VILLAGE OF PALATINE

AGENDA • AUGUST 6, 2019

1. 1150 W. Euclid Avenue - Lexington Lakes
Preliminary Planned Development to permit a 26-unit residential townhome development

- **Preliminary Planned Development to permit a 26-unit residential townhome development**

PROJECT NAME AND SHEET TITLE

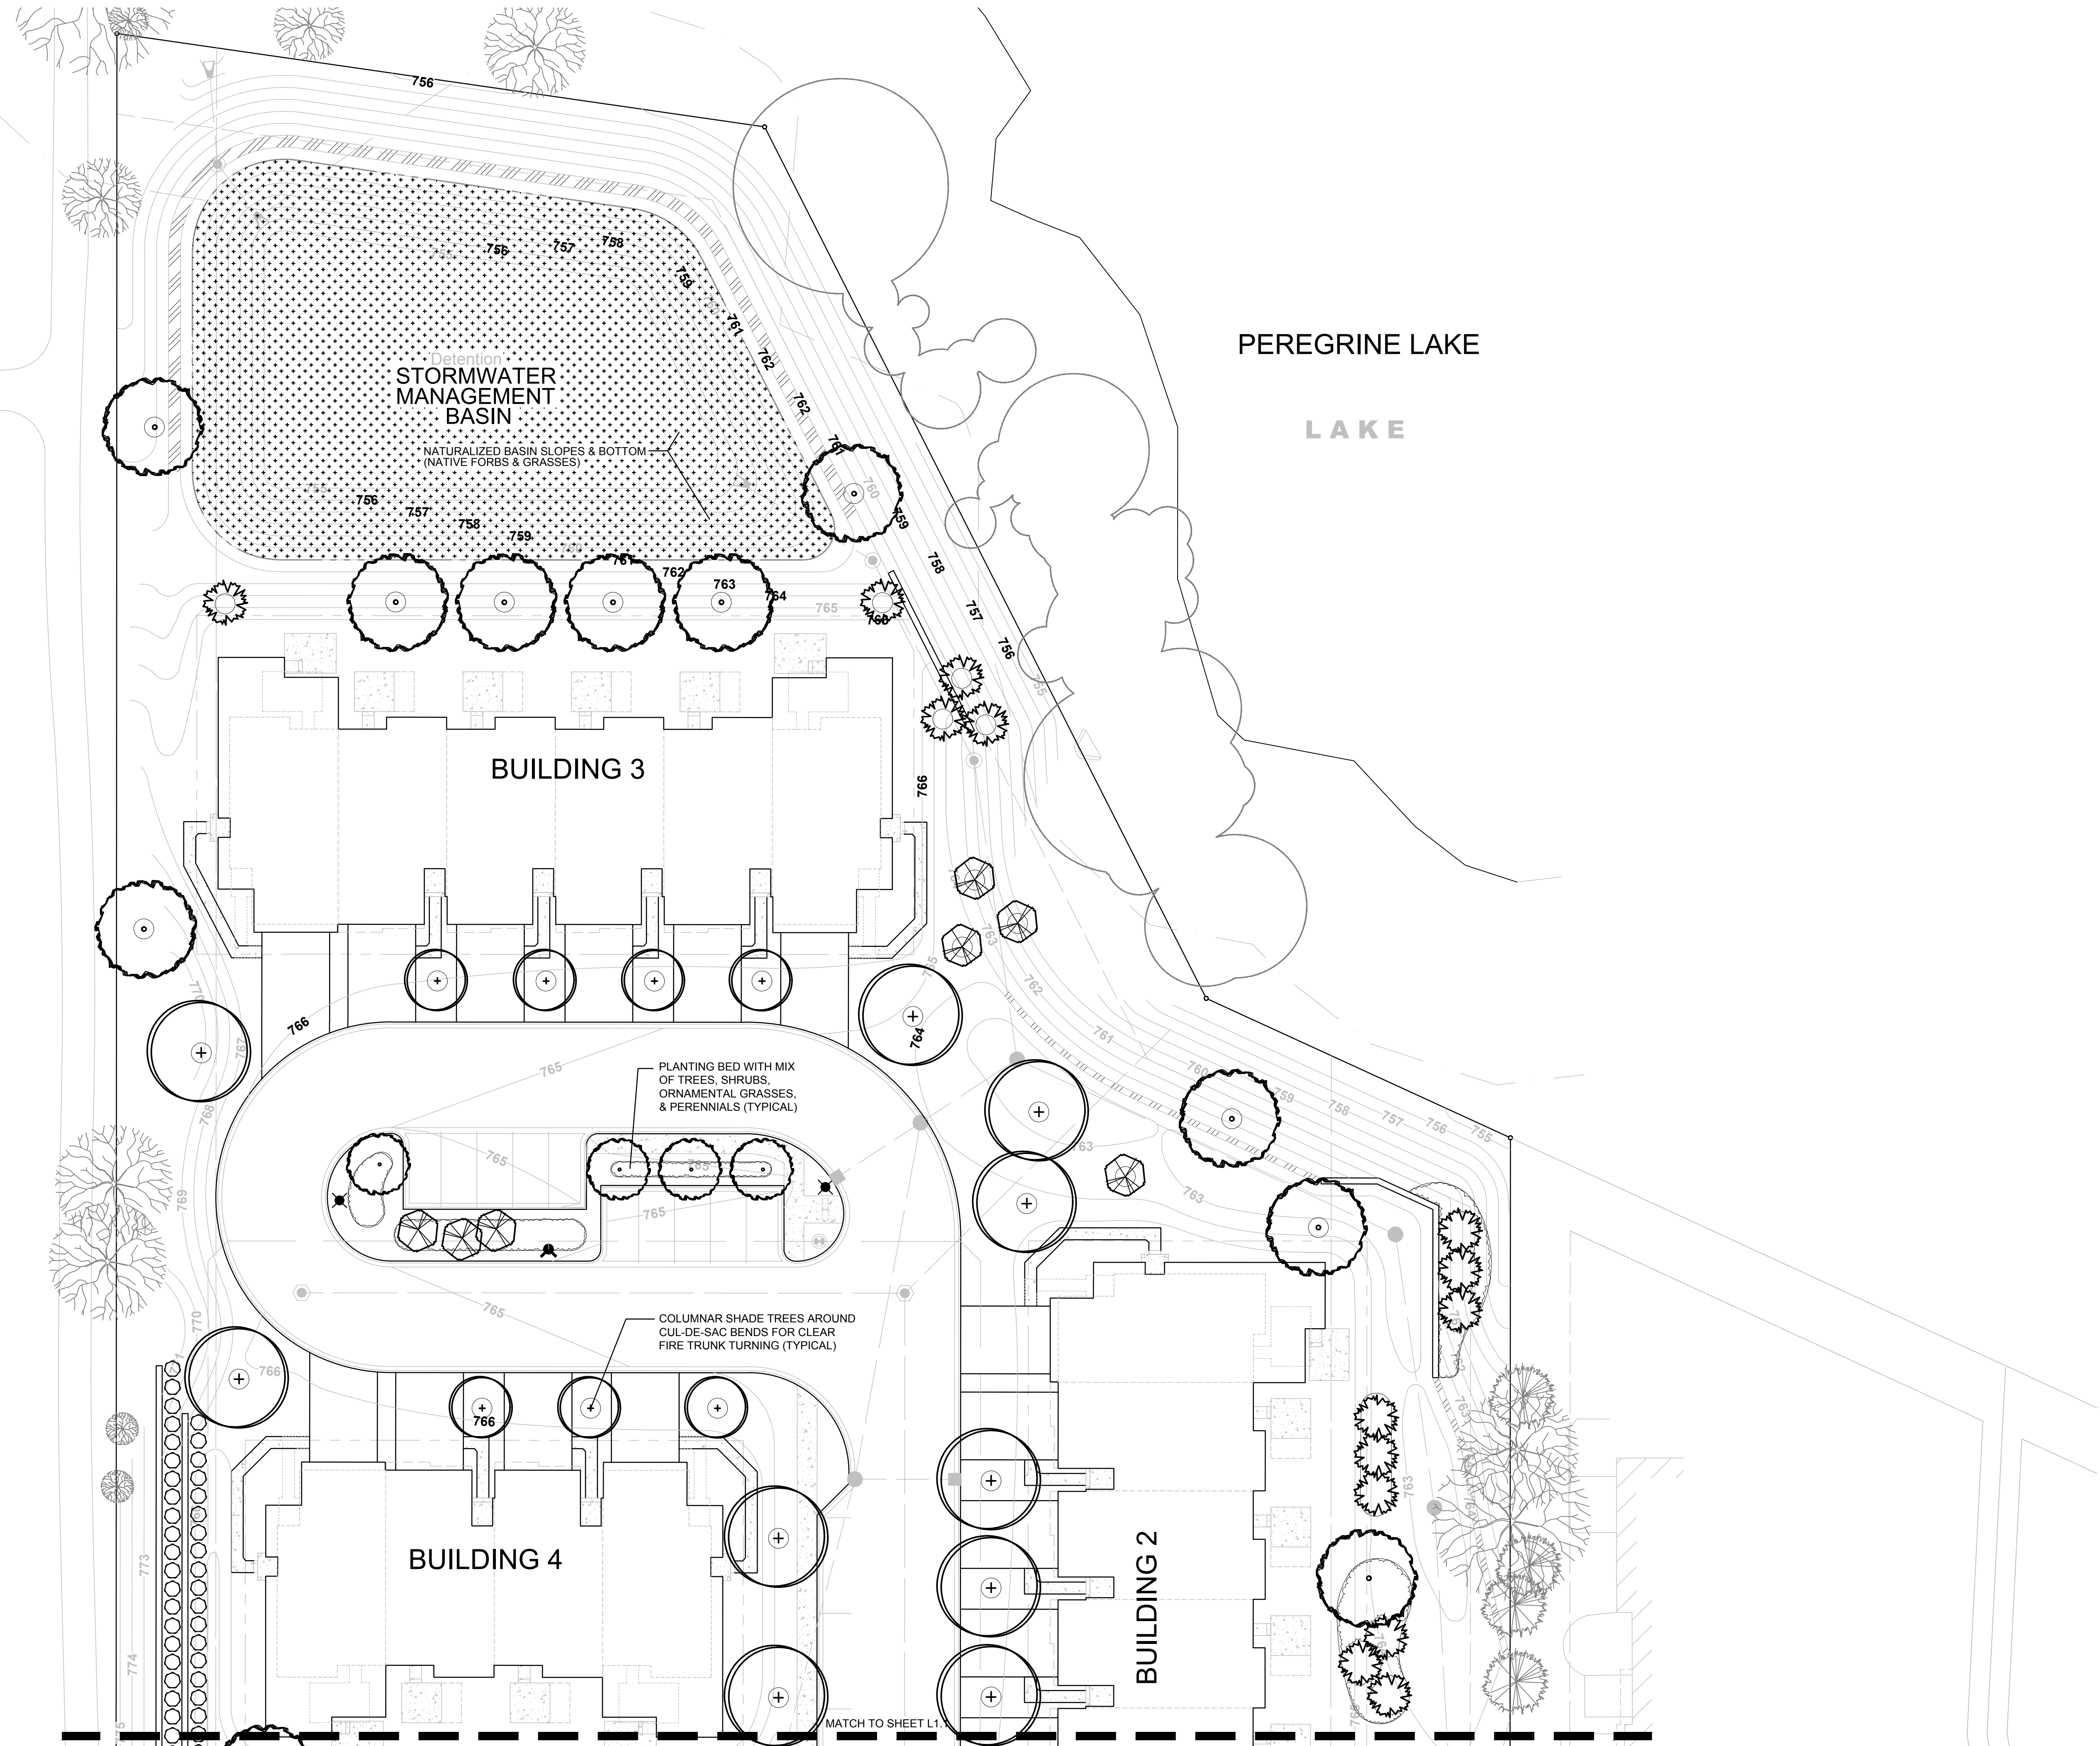
- Landscaping - The initial and revised landscape plans do not include additional foundation plantings as previously recommended by Staff. The initial landscape plan redistributed landscaping on the east side of the property at the expense of unit and foundation plantings within the site. Additionally, the 6 initially proposed parkway trees have been removed. While the landscaping plan will remain a component of final review, Staff has recommended additional unit and foundation plantings as previously proposed and this was not included in the revised landscape plans.
